NOTICE OF REVISION (NOR)				1. DATE (YYMMDD) 98-07-14	Form Approved OMB No. 0704-0188		
THIS REVISION DESCRIBED BELOW HAS BEEN AUTHORIZED FOR THE DOCUMENT LISTED.							
Public reporting burden for this collection is estimated to average 2 hours per response, including the time for reviewing instructions, searching existing data sources, gathering and maintaining the data needed, and completing and reviewing the collection of information. Send comments regarding this burden estimate or any other aspect of this collection of information, including suggestions for reducing this burden, to Department of Defense, Washington Headquarters Services, Directorate for Information Operations and Reports, 1215 Jefferson Davis Highway, Suite 1204, Arlington, VA 22202-4302, and to the Office of Management and Budget, Paperwork Reduction Project (0704-0188), Washington, DC 20503.  PLEASE DO NOT RETURN YOUR COMPLETED FORM TO EITHER OF THESE ADDRESSED. RETURN COMPLETED FORM TO THE GOVERNMENT ISSUING CONTRACTING OFFICER FOR THE CONTRACT/ PROCURING ACTIVITY NUMBER LISTED IN ITEM 2 OF THIS FORM.					2. PROCURING ACTIVITY NO.

3. DODAAC
4. ORIGINA	TOR		Defense Sup 3990 East B	Street, City, State, Zipop

## FIGURE A-1

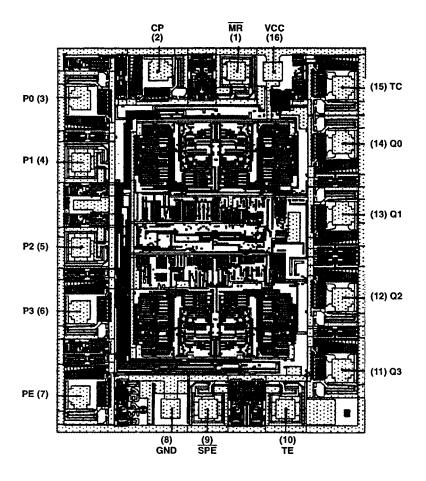
Sheet 4: Add new paragraph which states; "3.1.1 Microcircuit die. For the requirements for microcircuit die, see appendix this document."  Revision level block; add "A".					A to		
Sheets 18 through 24: Add attached appendix A.							
CONTINUED ON NEXT SHEETS

Die Size: 2650 x 2190 microns. Die Thickness: 21 +/- 2 mils.

The following metallization diagram supplies the locations and electrical functions of the bonding pads. The internal metallization layout and alphanumeric information contained within this diagram may or may not represent the actual circuit defined by this SMD.
